SIB 22 03 22

CREAKING NOISE FROM THE LOWER ENGINE AREA

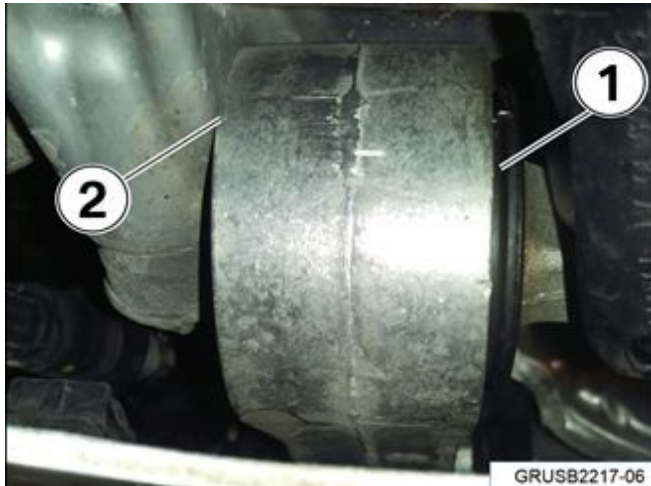
The bushing in the lower engine stabilizer link (1) is working its way out of its aluminum housing.

The aluminum housing starts to rub against the engine oil pan (2).

Confirm the noise is coming from the lower engine stabilizer link and replace the link.

NOTE: The replacement stabilizer link needs to be Index 02 or higher.
